**OLD PALM CITY NAC**  
**AUGUST 29, 2019**

- I. TITLE:** Request for alternative compliance at 895 SW 34<sup>th</sup> Terrace.
- II. THE APPLICANT REQUESTS ALTERNATIVE COMPLIANCE TO:** Construct a detached single-family dwelling which does not strictly comply with the requirements of Section 3.265, Old Palm City Community Redevelopment Area, Land Development Regulations, regarding the front porch and the two-car garage.
- III. BACKGROUND:** The zoning regulations applicable within the Old Palm City CRA, Section 3.265.M., provides:

Regarding; BLD2019070713

**Figure 1. Original Floor Plan**

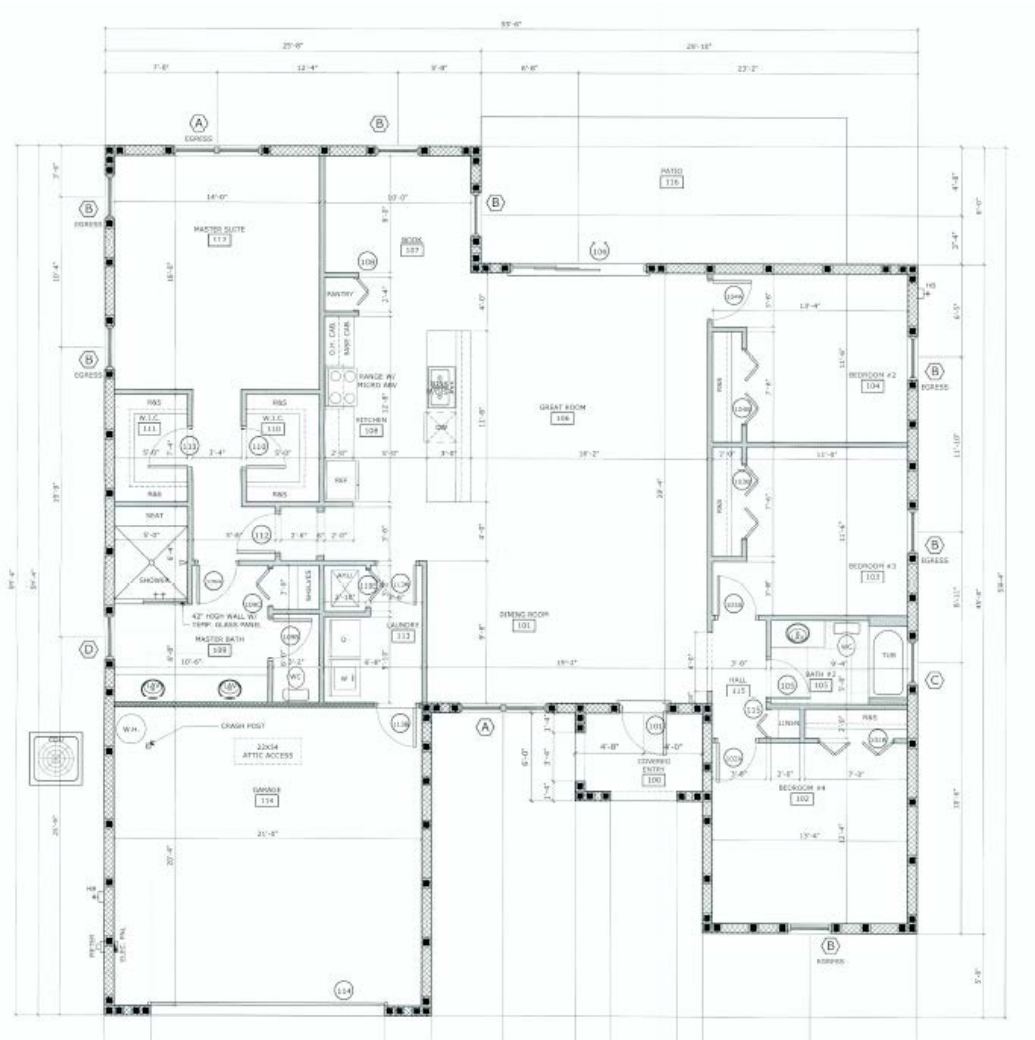
As initially submitted, the building permit application proposed (a) a front-facing garage, (b) a front set-back of 35 feet, and (c) a six-foot by 8-foot covered entry (48 square feet). The floor plan as originally proposed is provided as Figure 1. The original front elevation is provided as Figure 2.

Figure 3. Revised Floor Plan

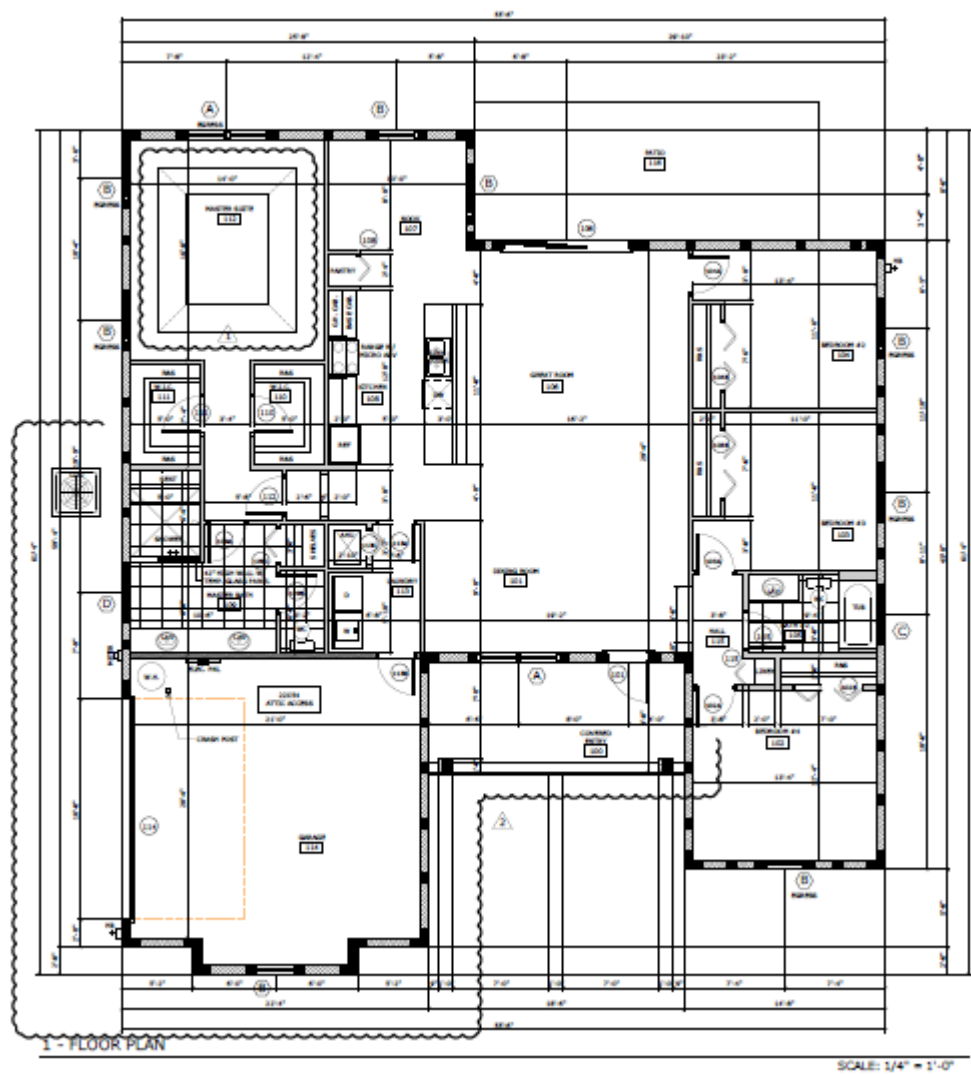
The house plans were revised to bring them into closer compliance with the Old Palm City requirements, while seeking to avoid a complete re-design that would cause delay and expense. The revised floor plan is provided as Figure 3.

- (a) The front-facing garage was redesigned to become a side entry garage and the front-facing wall was redesigned to look like a part of the living space, including a window. The revised front elevation is provided as Figure 4.
- (b) The site plan was revised to provide a 20-foot front setback.
- (c) The 6 ft. by 8 ft. porch was enlarged to occupy the entire space between the garage and the front room. The porch now measures 18.5 feet by 8 feet or 148 square feet.
